PLANNING COMMISSION MEETING
City Hall: 3750 Bridge NW
Wednesday, June 17, 2026 at 7:00 PM

TO: St. Francis Planning Commission
FROM: Beth Richmond, Planner
SUBJECT: Turtle Ponds 6th Addition Preliminary Plat
DATE: 06-10-2026 for 06-17-2026 meeting
APPLICANT: Home Improvement Shop Inc. (Bill Carroll)
LOCATION: 2761 229th Ave NW
COMP PLAN: Medium Density Residential (MDR)
ZONING: Turtle Run PUD

TO: St. Francis Planning Commission
FROM: Beth Richmond, Planner
SUBJECT: Top Tier Automotive Site Plan
DATE: 6-10-2026 for 6-17-2026 meeting
APPLICANT: Structural Buildings, Inc. (Derek Anderson)
LOCATION: Between Hwy 47 and Aztec St NW (PIN 32-34-24-32-0073)
COMP PLAN: Commercial
ZONING: B-2 General Business

RE: Top Tier Auto Site Plan Review No. 1

TOPOGRAPHIC INFORMATION - PROPOSED

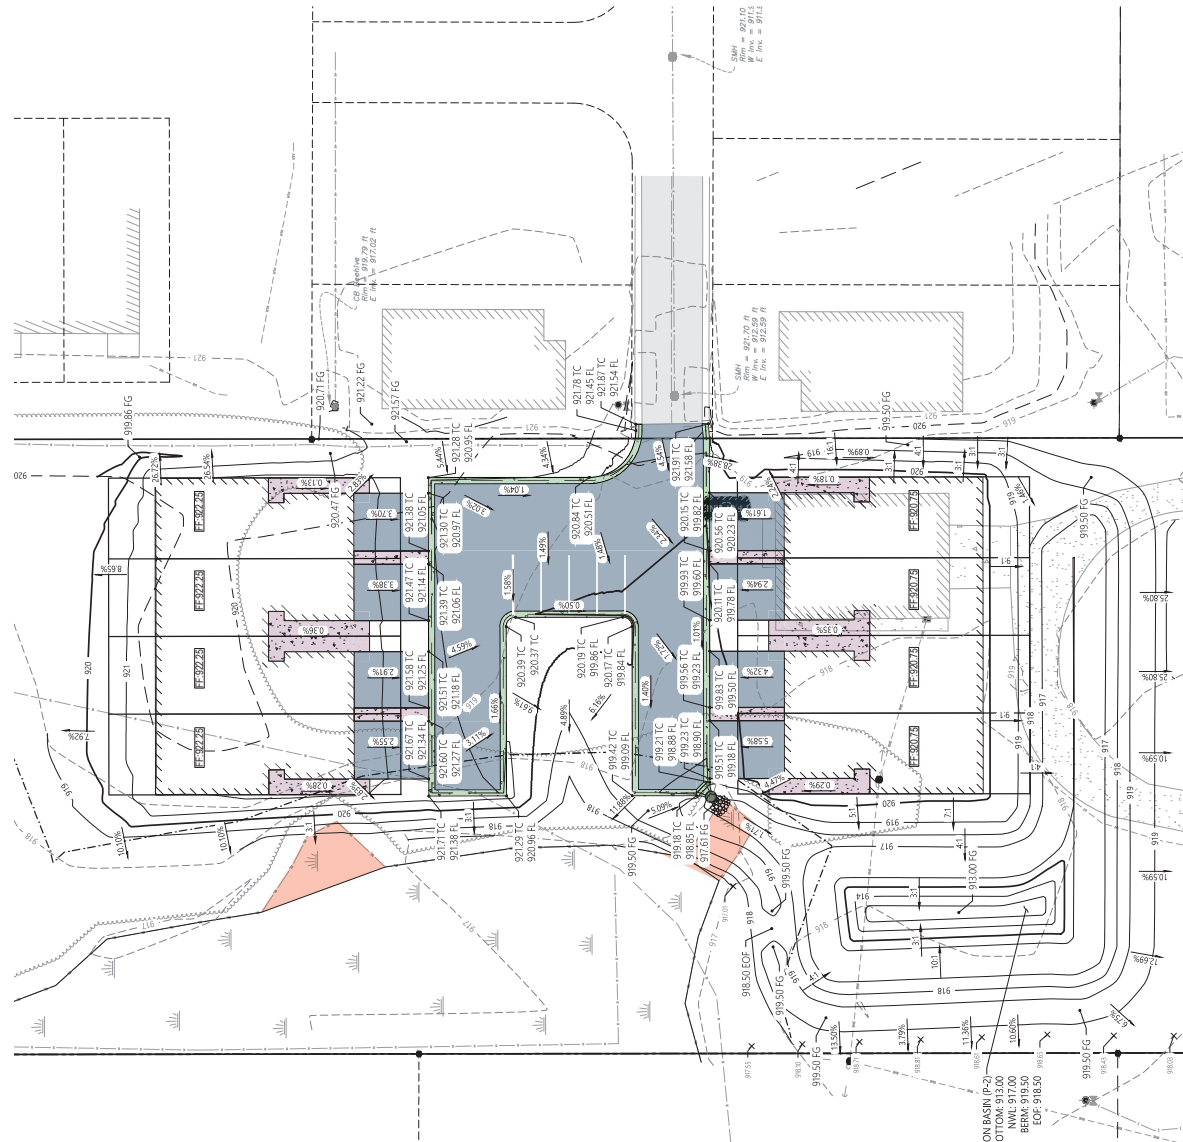
1. Provide a profile view of the proposed outlet structure OCS 2.
2. Show the proposed storm sewer on sheet C7.01.
3. Provide the 100-yr HWL on sheet C7.01.

4. Grading is being performed along the eastern property line north of 229th Lane. The Applicant shall review and revise this area as no grading shall be allowed on neighboring properties without permission. Grading shall also be revised so that the neighboring properties do not receive any drainage from the proposed site.

5. The Applicant shall add the lot and block numbers to sheet C7.01.
6. The Applicant shall provide the proposed house type for each lot as well as the garage floor elevation and the lowest opening elevation.

12. Add all wetland buffers to sheet C7.01.
13. Provide mulch type and application rates.

TOP TIER AUTO
 AZTEC STREET
 ST. FRANCIS, MN
 SWPPP - PLAN VIEW

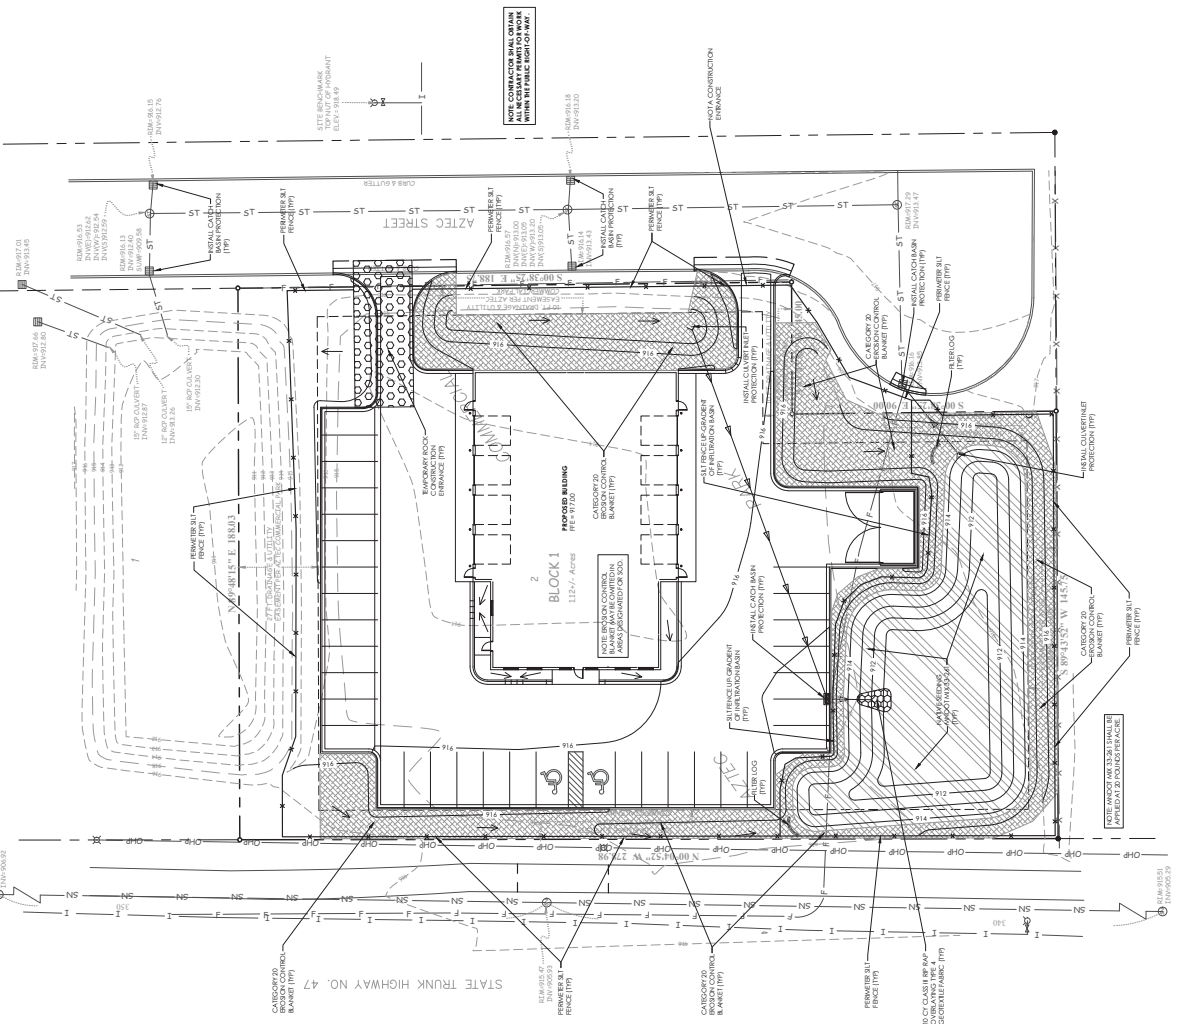
2. Sheet C2 and Sheet C4
 - Show the building and parking setbacks.
 - Driveway aprons shall be constructed per City Standard Plate 702. Replace detail 9 with City Standard Plate 702 on sheet C4.
 - The trail section on the east side of the property shall be constructed per City Standard Plate 707. Add City Standard Plate 707 to detail.
 - Add the City Standard Plates for sewer and water service details.
 - A MNDOT permit will be needed for the proposed work in their right-of-way.

3. Sheet C3
 - Review all notes and add the City Standard Plates for sewer and water service details.
 - Add the specific material type for the watermain service pipe. For HDPE, the City allows High Density Polyethylene SDR 11.
 - Sanitary sewer service pipes and fittings shall be PVC SDR 26, regardless of bury depths. All service pipe connections shall be solvent welded. Review and revise notes as necessary.

4. Sheet C5
 - Show the size of the existing catch basin that will be connected into at Aztec street. Catch basin will need to be replaced if smaller than a 48-inch diameter catch basin.
 - Provide additional spot grades along the Aztec Street driveway tie ins.
 - Low points are in the curb with no call outs for catch basins or tip-out curb to direct stormwater elsewhere. Review and revise if necessary to avoid stormwater ponding in curblines.

- Show an ADA accessibility route from the handicap parking stalls to the entrance of the building. It appears the slopes exceed allowable slopes.
5. Sheet C6
